15 April 2020

Drury South Limited  
c/- Barkers and Associates  
PO Box 1986  
Auckland 1140

## **PATAMAHOE SOUTH ACOUSTICS – RESPONSE TO PLAN CHANGE RFI QUERIES**

**Figure 1: Precinct plan illustrating proposed zoning changes**

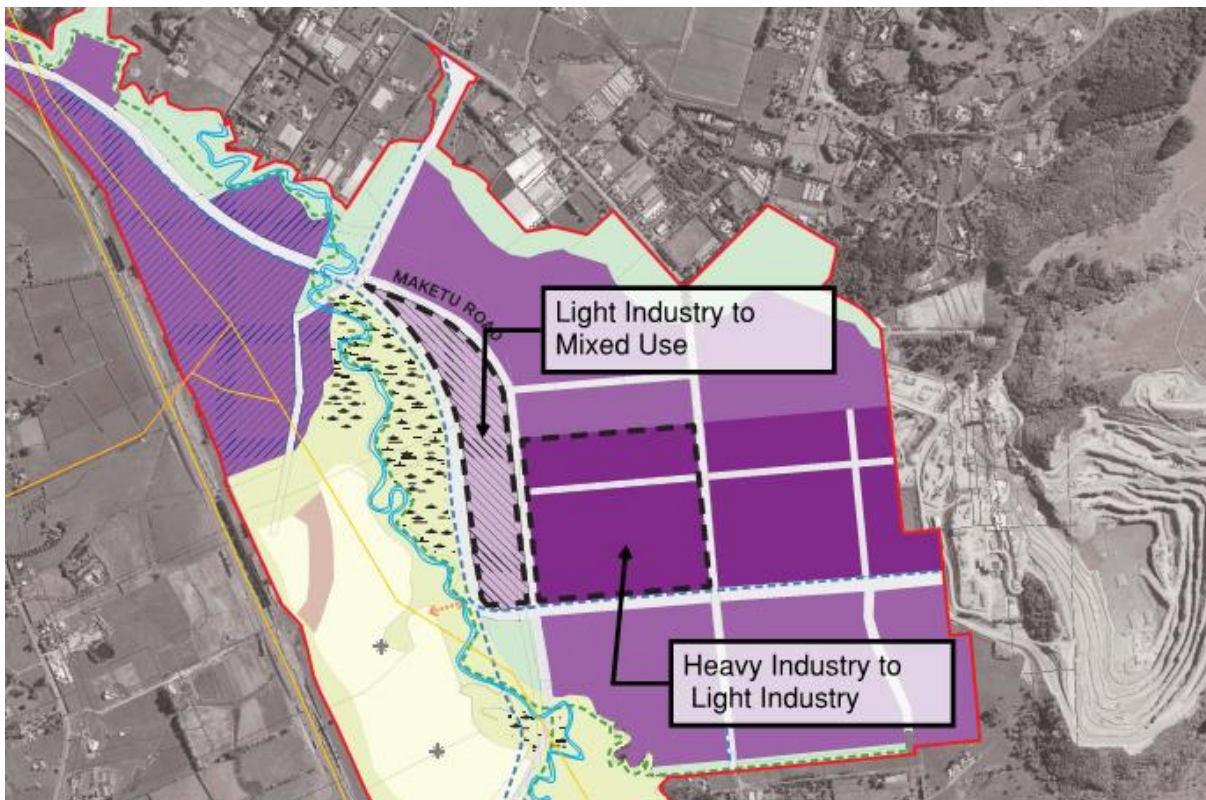
The Council has requested confirmation whether an acoustic buffer zone is intended or required over Sub-Precinct C. If a buffer zone is proposed, the Council requests confirmation of the location and dimensions of the buffer.

For residential development, one way of complying with this rule would be to provide an acoustic buffer of at least 20 m to separate Maketu Road traffic from the nearest buildings containing noise sensitive activities. It is envisaged that some of the buffer zone would include a bund, however, given the size of the permitted buildings it is considered that the bund would not provide any acoustic screening to the elevated levels of buildings.

The expected incident noise level at the façade of the nearest buildings at the boundary of a 20 m buffer would be 72 dB  $L_{Aeq(24\ hour)}$  and the required noise reduction for the façade to be 32 decibels.

It is considered that the provision of a 10 m buffer is not the only method to achieve an acceptable level of noise. The required noise reduction from road traffic noise to comply with no more than 72 dB  $L_{Aeq}$  could be achieved through the design of the building to is commercial spaces to act as buffers or elements of the building façade to screen noise sensitive spaces. The important aspect would be to ensure that the facade of any noise sensitive space in Sub-Precinct C was not exposed to a noise level greater than that permitted by the Rule I410.6.4.

To control the noise emission to noise sensitive spaces and to allow the buildings to be design without the necessity of an acoustic buffer, it is recommended that a further noise rule be included as part of the PPC:

*In addition to clause (1), the noise level measured at the façade of any part of a building that provides outlook from principal living rooms or bedrooms to Maketu Road as required by rule H13.6.9, must not exceed 70 dB  $L_{Aeq(24\ hour)}$ ”*
